RE: Approval of Phase I Bond Release, Huntington #4, ACT/015/004 #5, Emery County, Utah

Phase I Bond Release Inspection at Huntington #4,

ACT/015/004, #5, Emery County, Utah

PLATE 3-8
HUNTINGTON #4 RECLAMATION
POST-MINING TOPOGRAPHY
ORIGINAL SCALE 1"=200'

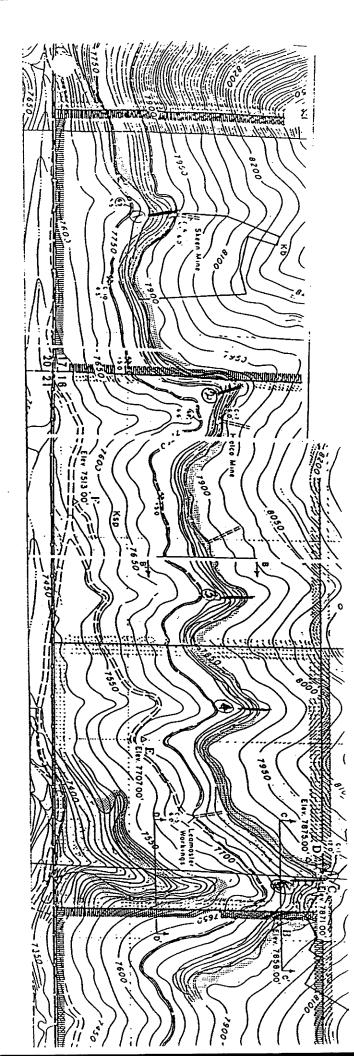
Plate 3-8 in the approved plan indicates the reclaimed (post-mining) topography. A reduced copy of this plate (attached) designates areas in drainages (totalling less than a half acre) that may be potential erosion problems. The steepness of the terrain and intensity associated with thunderstorms may require some earthwork and repair in the future. Some tension or settling cracks were noted that should be observed and monitored in the future.

NOTE: DRAINAGES AND SETTLING OR TENSION CRACKS INDICATED
